J2025-0107
PSP2025-0006
Revision #2
Received 6/13/2025

Site Plan Review

Reviewed for compliance with City Ordinance, Building and Fire Codes
Conditions and mark-ups noted throughout plan set must be addressed prior to final approval

OWNER/PROPRIETOR
PINE TRACE GOLF COURSE
3600 PINE TRACE BOULEVARD
ROCHESTER HILLS, MICHIGAN 48309
MICHAEL BYLEN
MICHAELBYLEN@GMAIL.COM
248-852-7100

C6

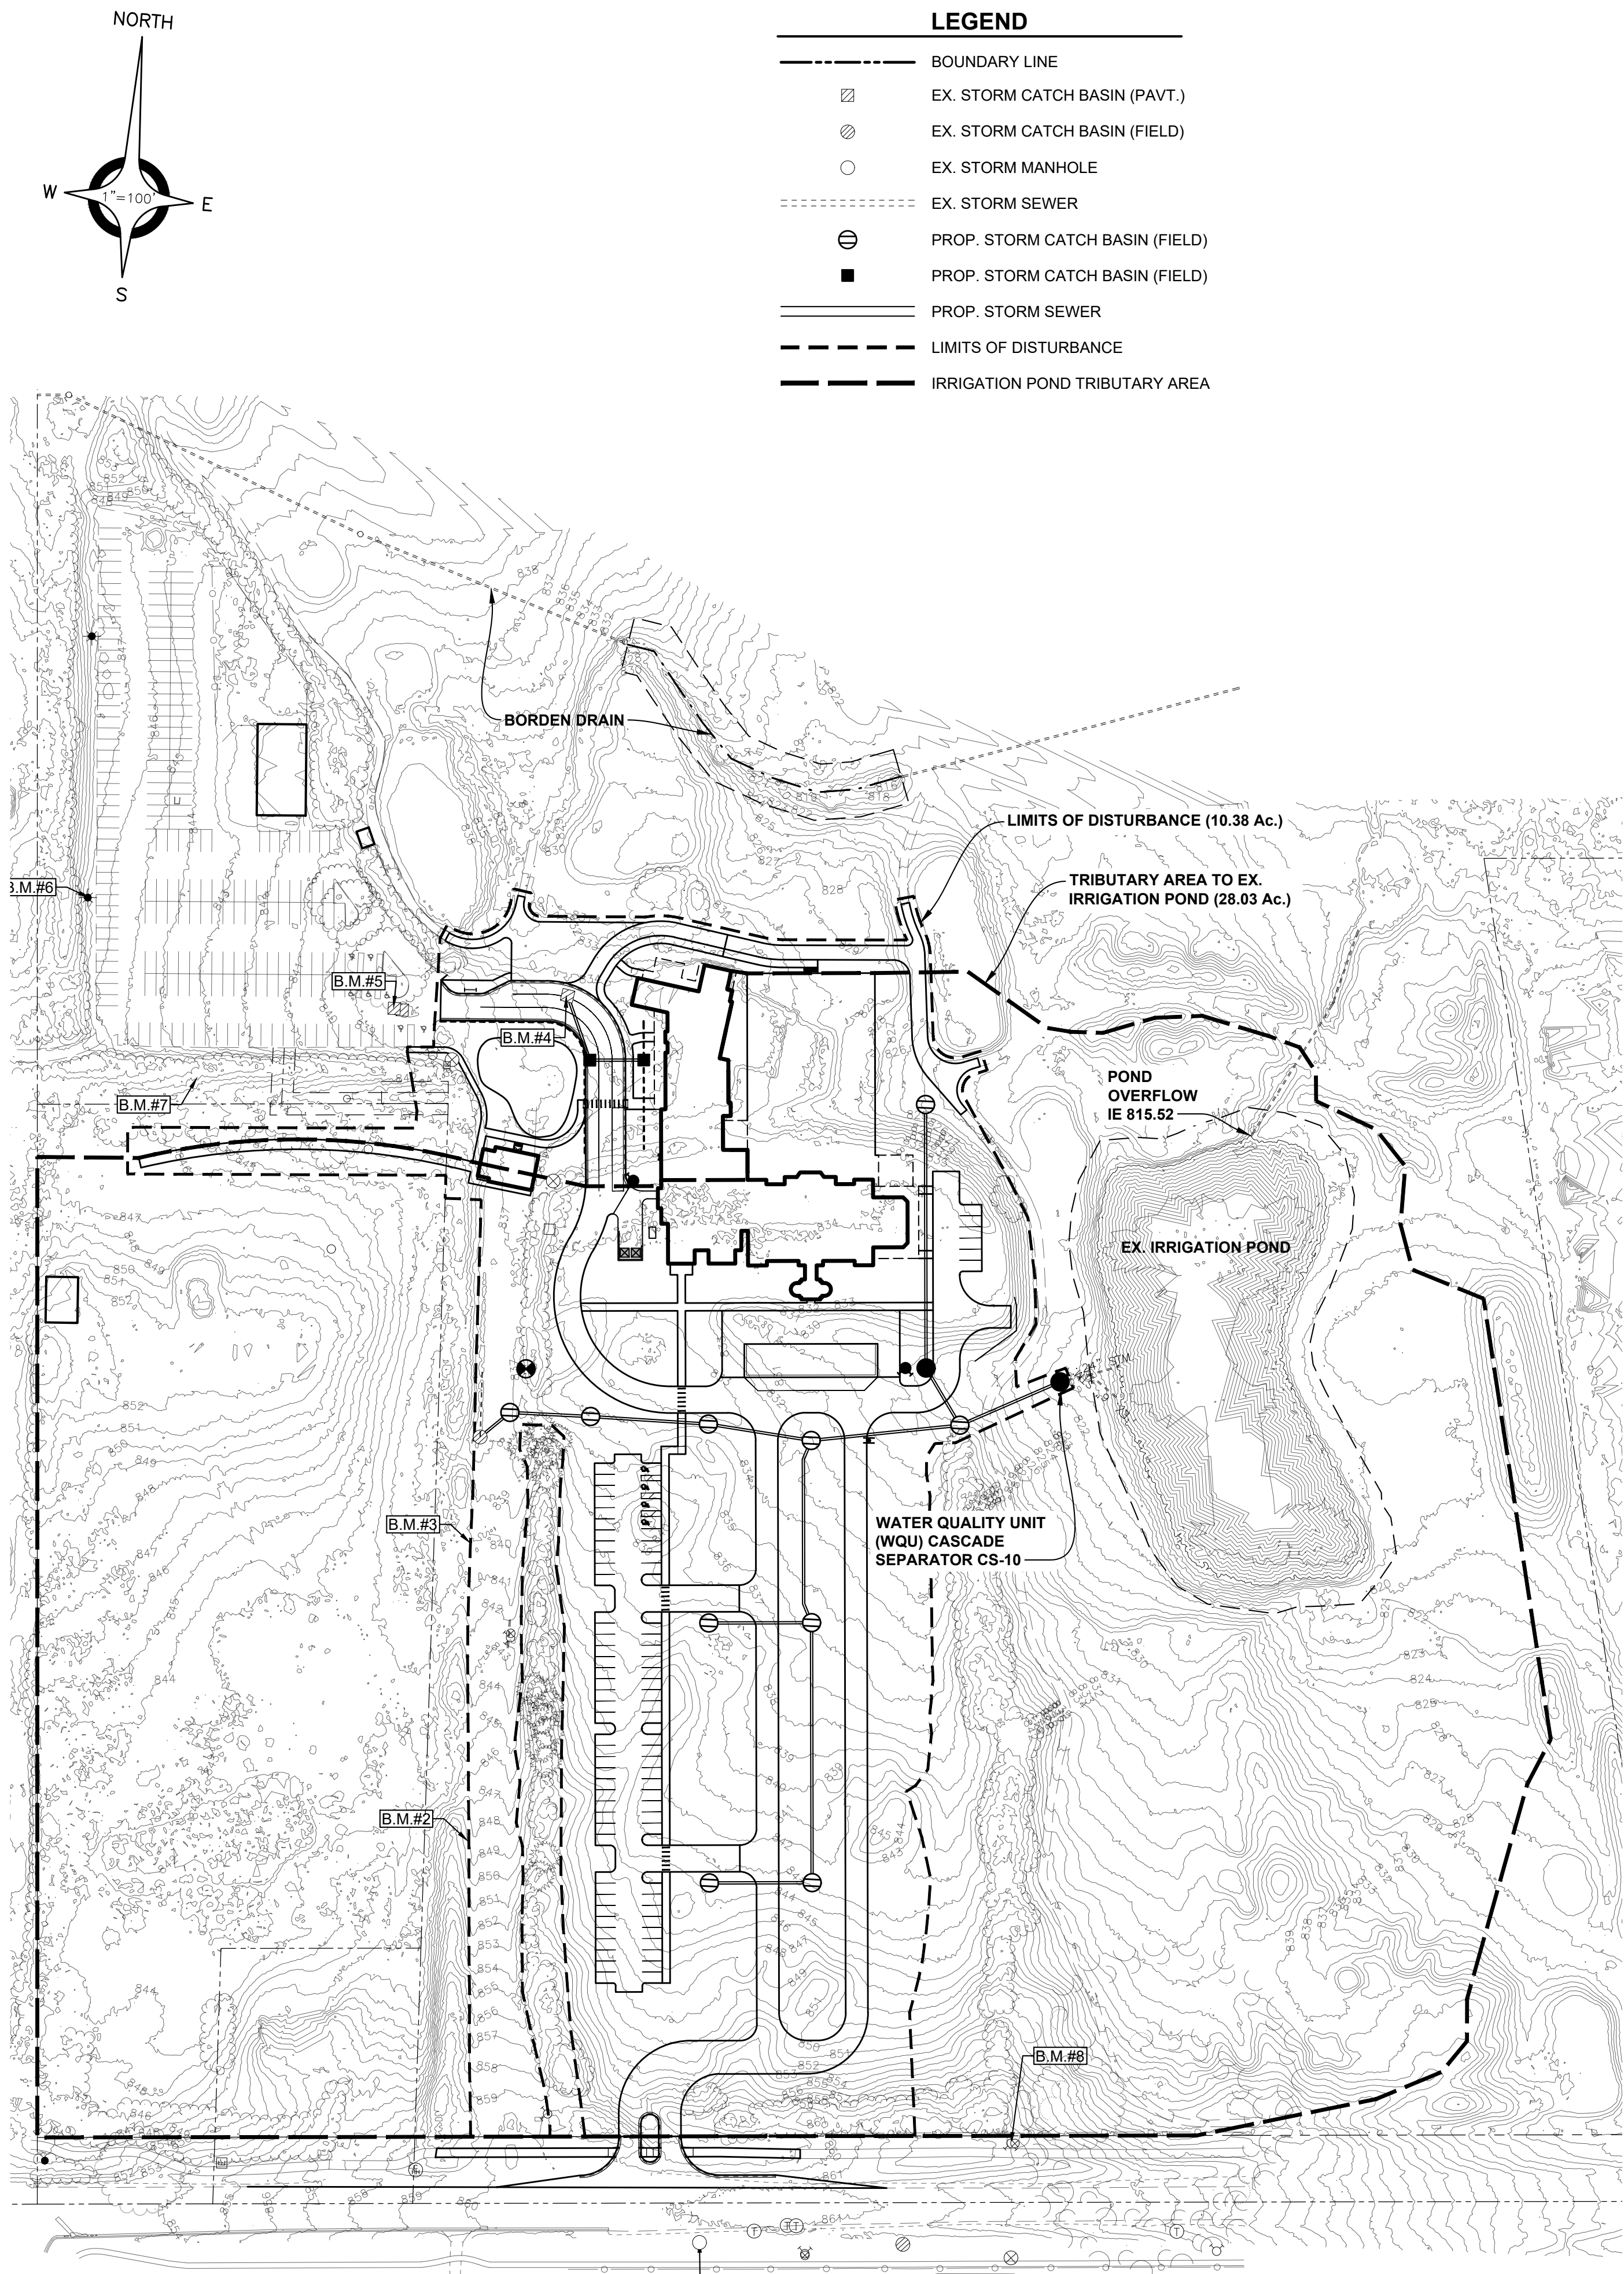
Defined as wetland on City mapping. If any work is proposed in or around wetland area, delineation will be required and appropriate wetland use permit will be required (as applicable). No action necessary at this time. Comment is informational only and shall become applicable if work is required either in the defined wetland area, within the natural features setback, etc.

STORM WATER MANAGEMENT PLAN

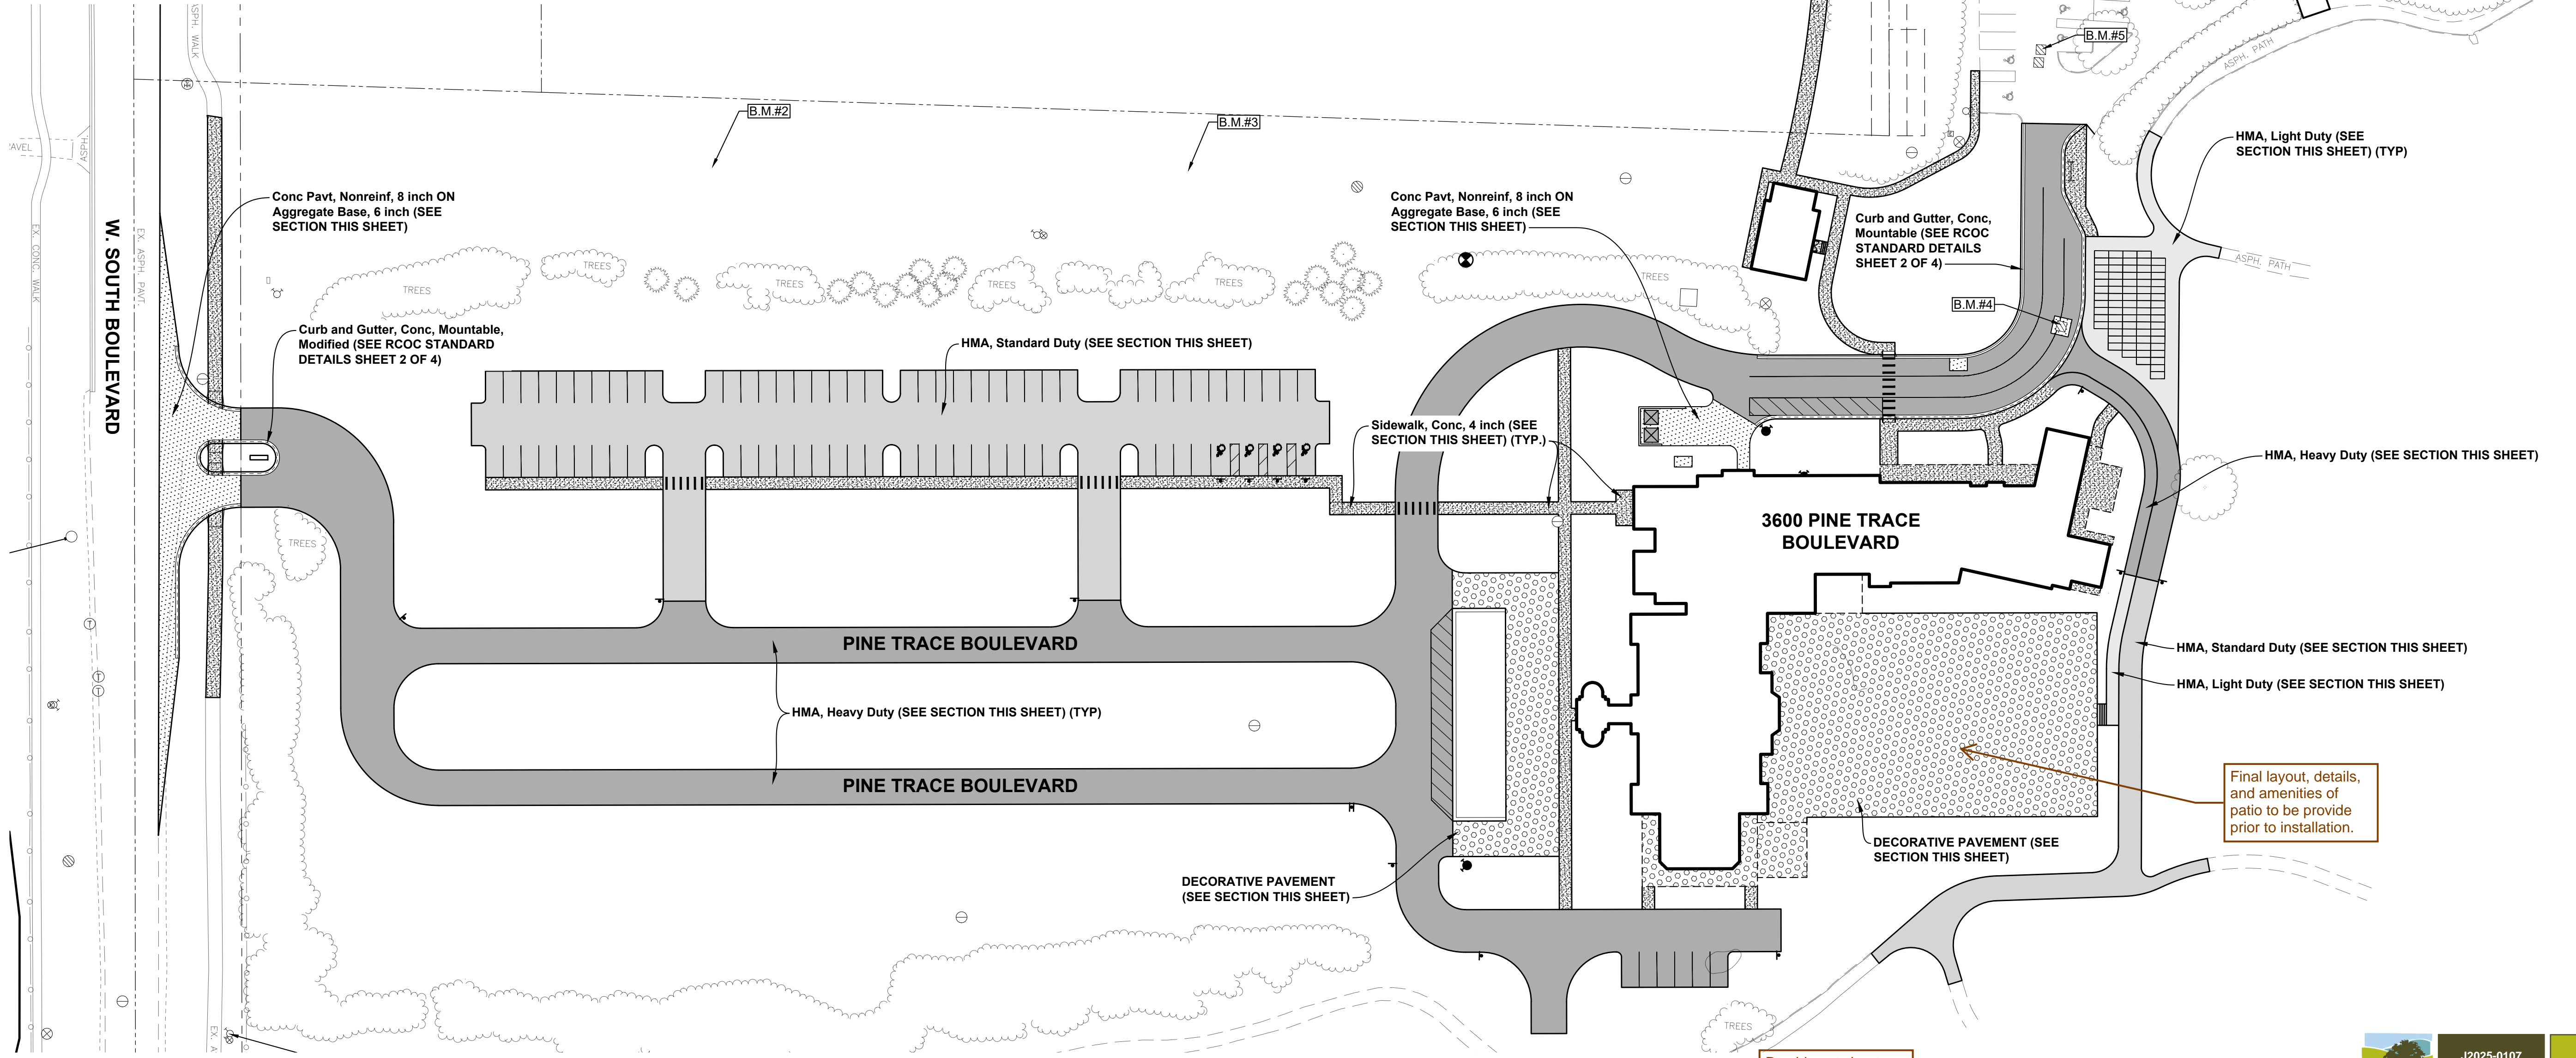
Provide documentation from the WRC stating that this narrative is acceptable to them. If no letter/email from WRC is provided then all storm sewer standards need to be met fully.

PAVING PLAN

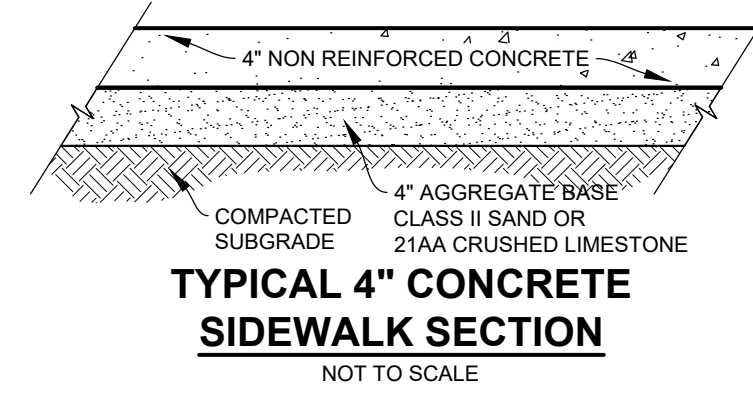
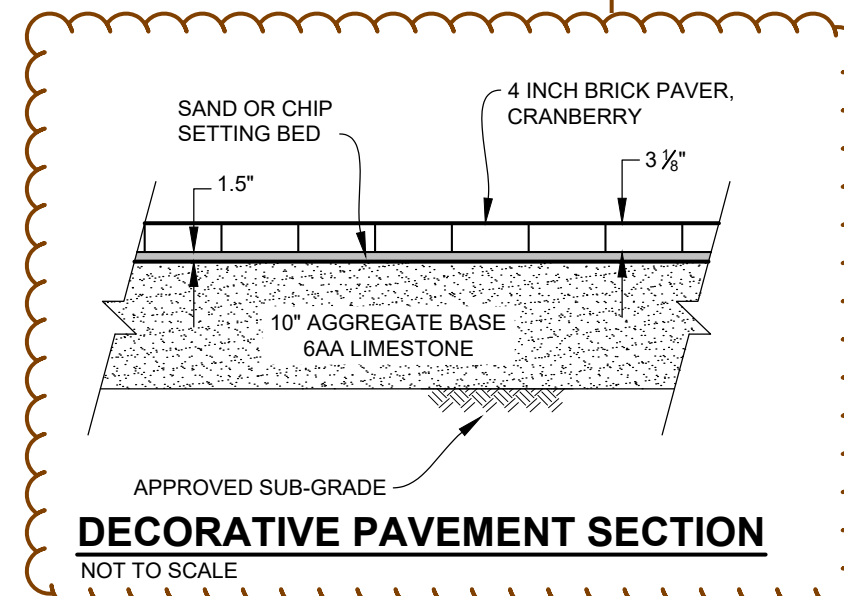
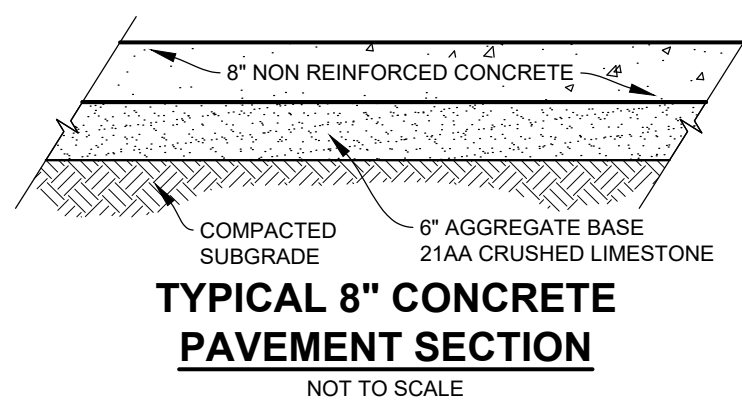
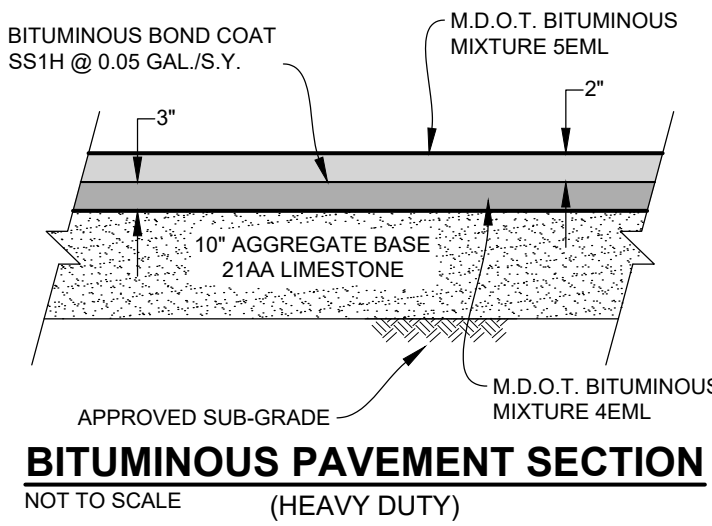
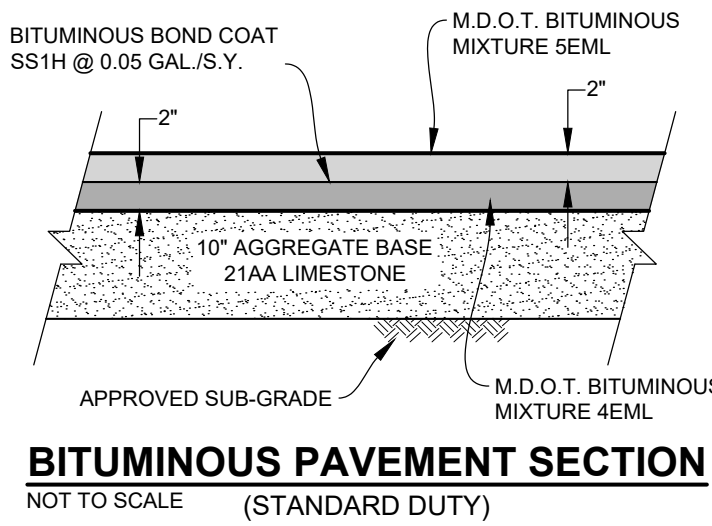
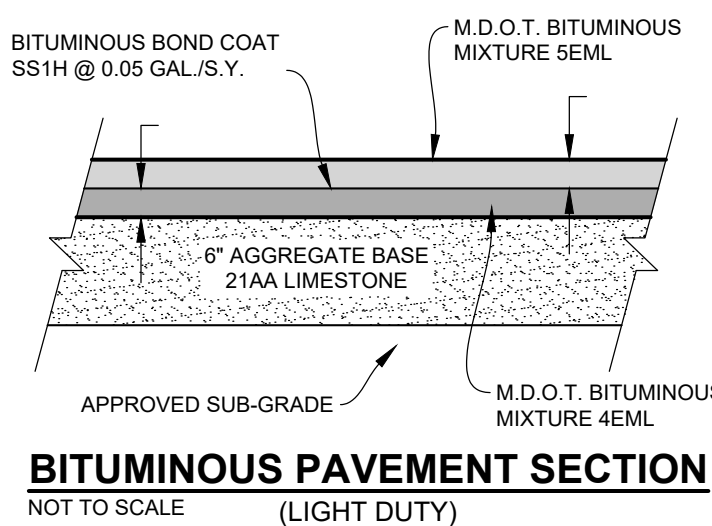
Provide cut sheet showing type of brick paver, color, layout, etc.
